SUNDRY NOTICES AND REPORTS ON WELLS

OXY USA Inc. - Current
Antelope Ridge #6
API No. 30-025-26291

**OXY USA Inc. - Proposed
Antelope Ridge #6
API No. 30-025-26291**

**Antelope Ridge Unit 6
30-025-26291
OXY USA Inc.
March 17, 2009
Conditions of Approval**

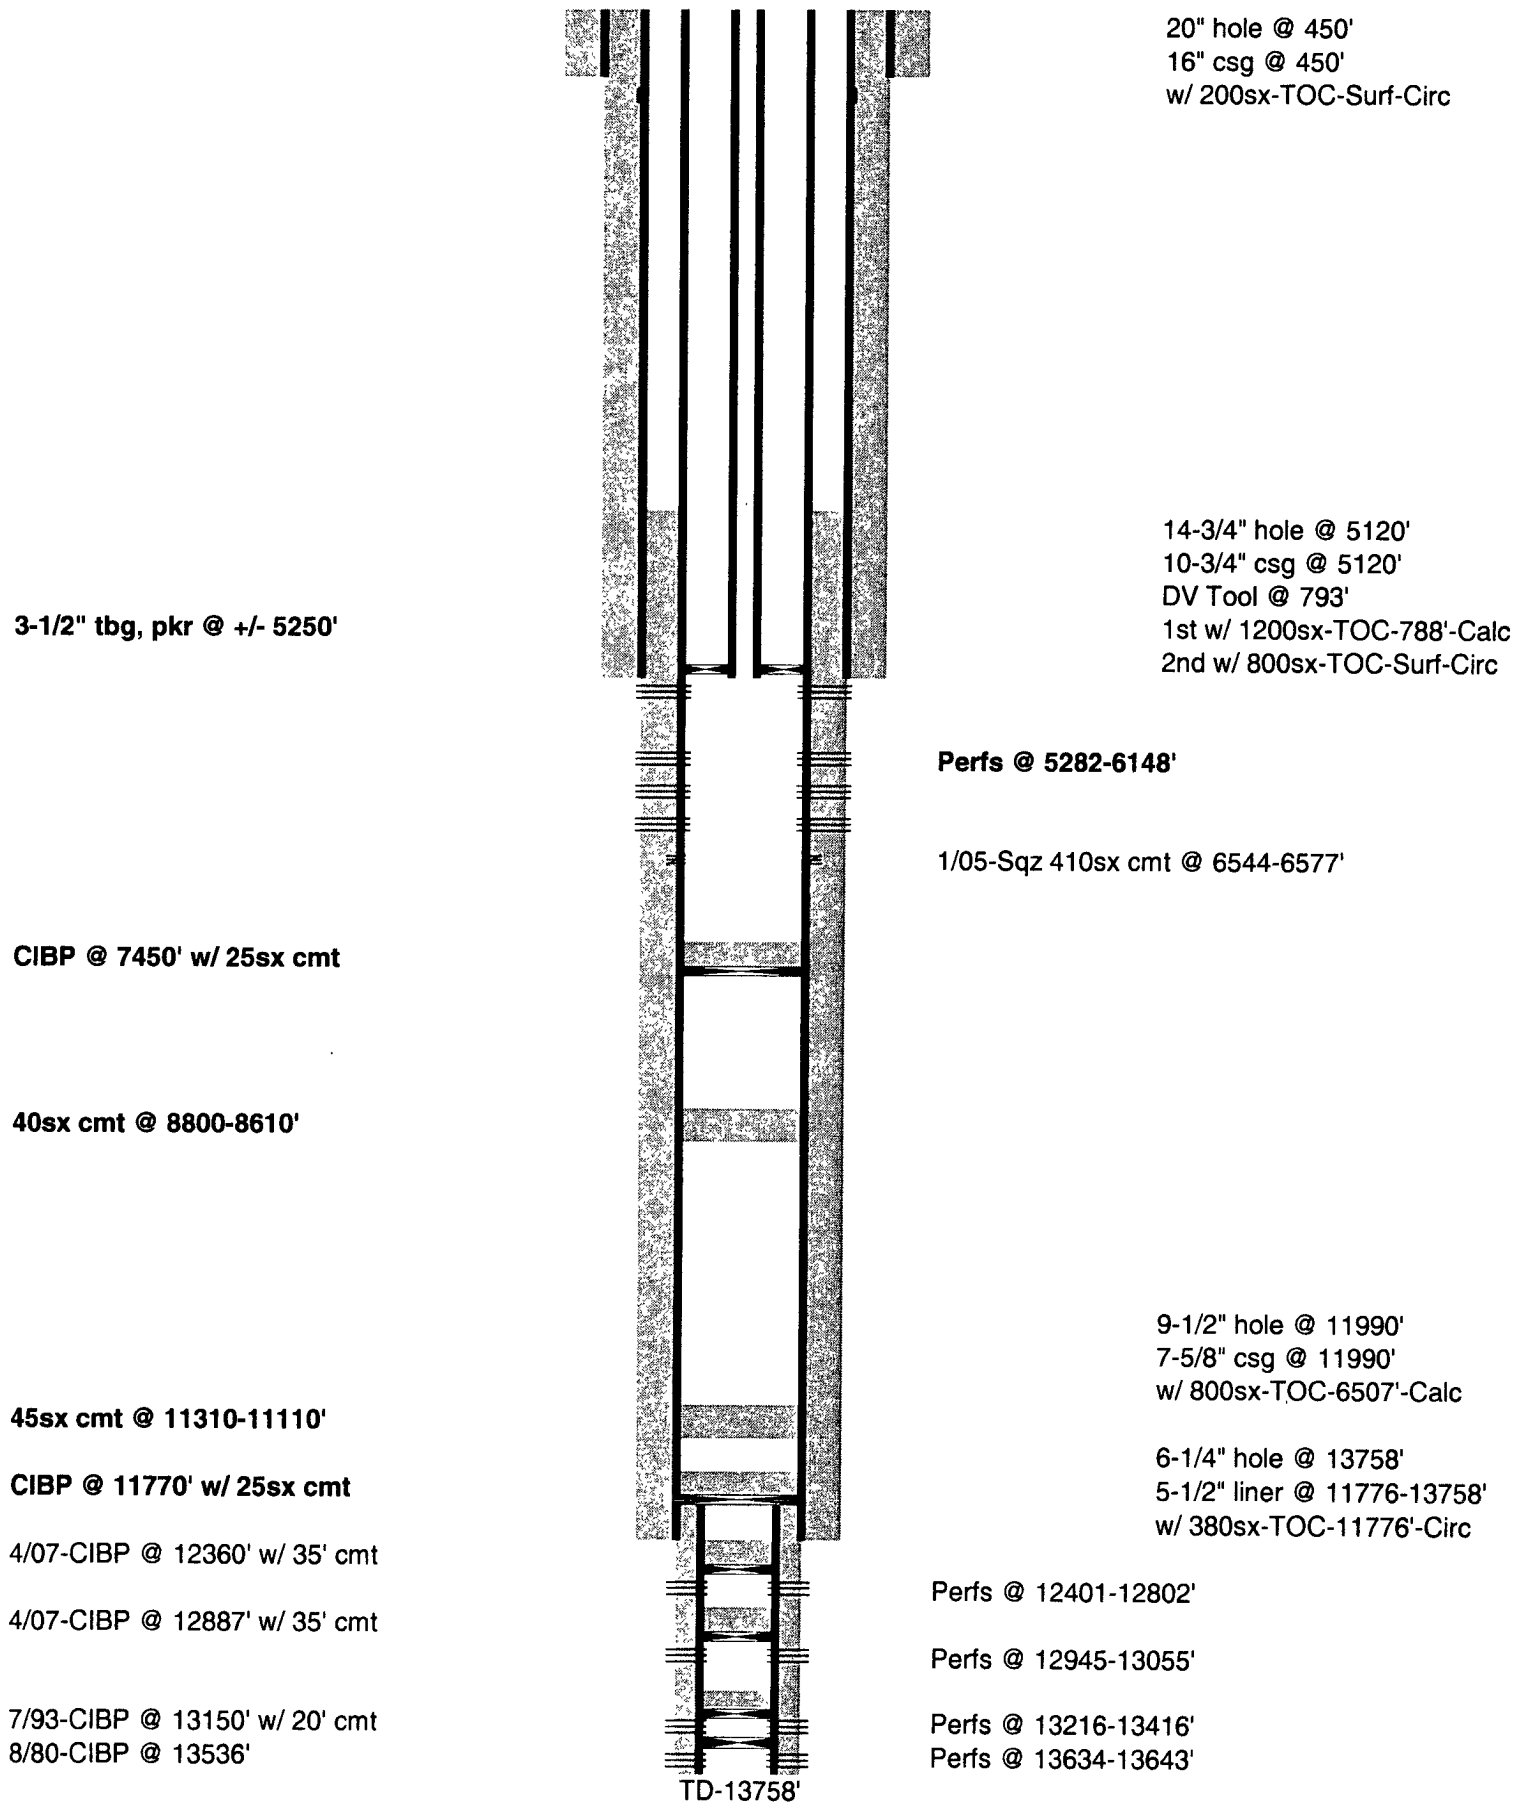
- 1. Operator to request extension on NMOCD injection permit as it was effective through December 12, 2008 for Bold Energy, LP and operator change occurred on June 1, 2008.**
- 2. Plug in step 4 to be 210' in length to meet Onshore Order requirement of 100' plug 10% for each 1000'.**
- 3. CBL copy to be sent to BLM.**
- 4. Step 7, casing to be tested to maximum injection pressure expected.**
- 5. Subsequent sundry required detailing all work completed and date well placed on injection.**
